Lower Hassayampa River Sediment Transport Model Update Summary Final Report

FCD2014C002

Prepared For:
Flood Control District of Maricopa County

Subject: Hassayampa River Sediment Transport Models Update Contract #2014C002/ Summary Final Report (draft) dated May 2015, updated HEC-6, HEC-6T, HEC-RAS, and Fluvial-12 models, and Atkins' updated comment responses dated 6/16/2015 but submitted on 6/25/2015

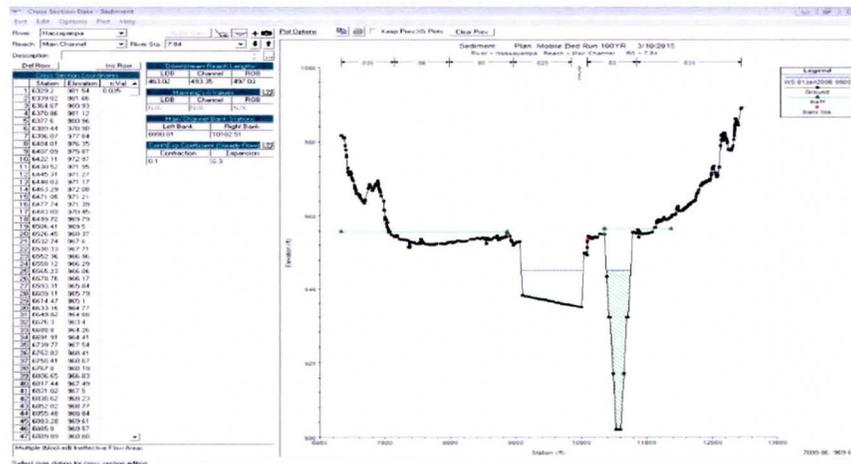
- (FCD 4/1/2015)** In the ultimate HEC-RAS sediment transport model, the pit with the berm with protection (XS 7.84-8.13 and XS 15.59-15.87) is blocked

using ineffective flow approach. Since flow never gets into the pit, the pit should be blocked completely either by using levee or obstruction.

(Atkins 5-27-2015) Action Taken: Pits with bank protection in the “Ultimate Pit Model” have been blocked using levees instead of ineffective flow areas.

(FCD 6/9/2015) Okay. The ultimate pit condition model is updated. Comment resolved.

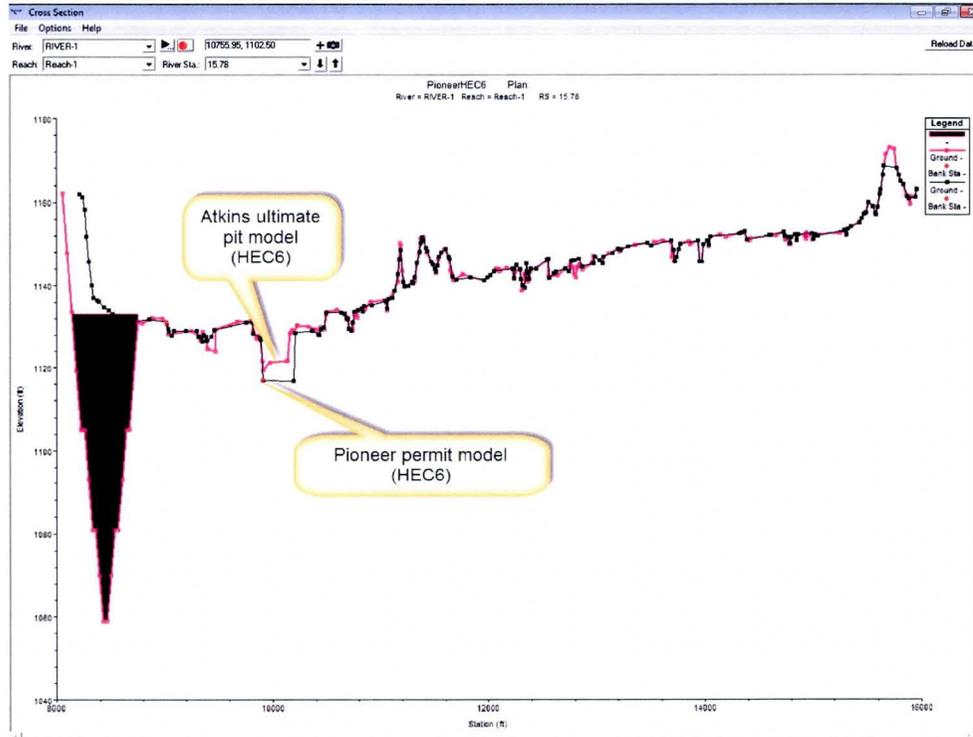
- (FCD 4/7/2015) The channel in the XS15.68, XS 15.78, XS 15.02 and XS 14.92 should be modeled according the permit in ultimate pit condition. Below is the screenshot showing the difference in Pioneer permit model and Atkins ultimate pit model. Please verify the depth of the channel from the permit.

(Atkins 5-27-2015) Action Taken: It was determined that the geometry in the Atkins “Ultimate Pit Model” matches the approved plans for the pit.

(FCD 6/9/2015) Okay. Comment resolved.

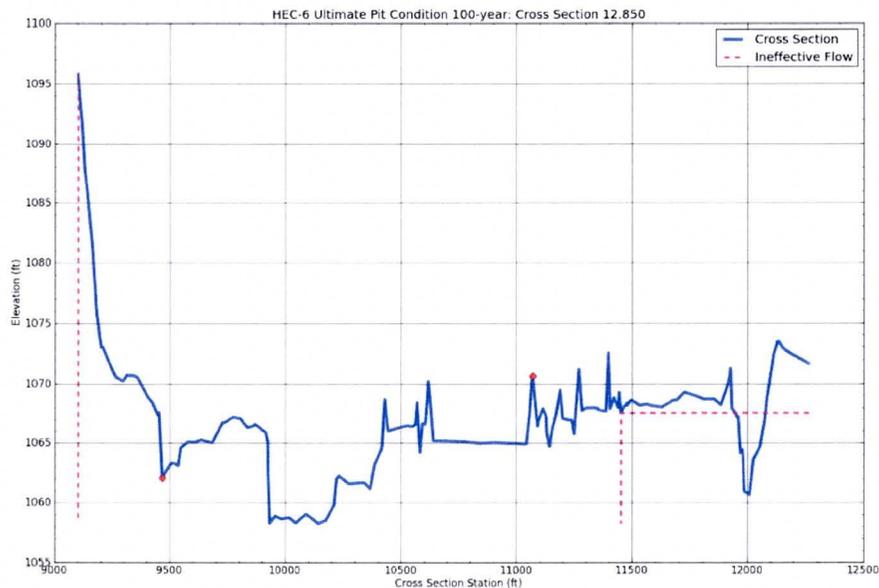
22. **(FCD 6/9/2015)** According to Hanson Aggregate Closure Plan, the filling on the North side of the Pit 1 is at elevation 1068, but in the models the elevation shown at XS 12.85 is around 1065 for the ultimate pit condition. Please verify.

(Atkins 6-25-2015) The Closure plans for Hanson Aggregate Pit 1 indicate a fill elevation of 1068. The geometry for all four Ultimate pit models have been updated.

(FCD 6/30/2015) Comment resolved.

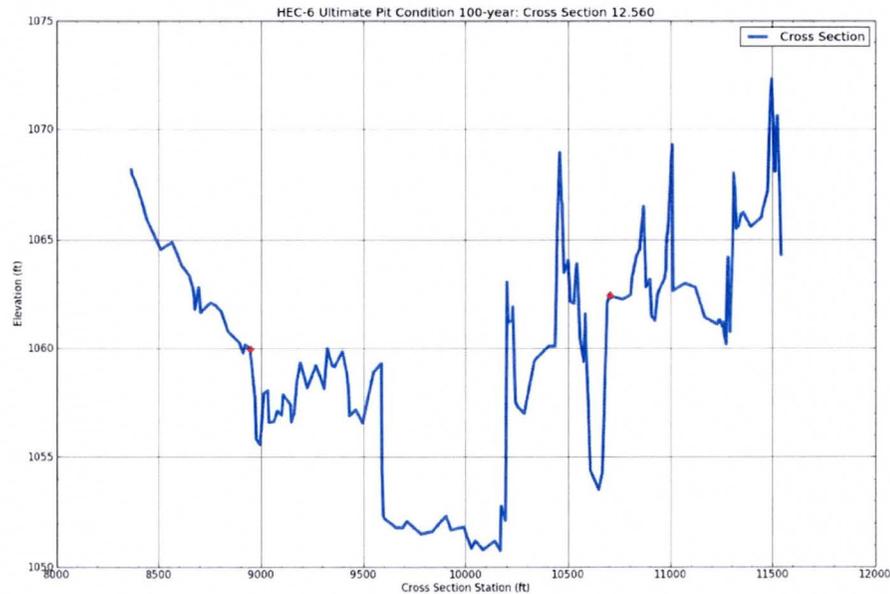
23. **(FCD 6/9/2015)** Attached below is the plot of HEC 6 input data at XS 12.56. The lowest elevation is about at 1051 ft. However, Hanson Aggregate Closure Plan has the bottom elevation of Pit 2 (floodway pit) of 1048 ft which does not match with the plot below. Please verify this for all sediment transport models (HEC-6, HEC-6T, HEC-RAS, and Fluvial-12).

(Atkins 6-25-2015) We have confirmed that the bottom of cross section 12.56 should be between 1048.26 and 1047.5. Cross section 12.56 for all four Ultimate Pit Models have been edited to be in accordance with the closure plans for Hanson Aggregate Pit 2.

(FCD 6/30/2015) Comment resolved.
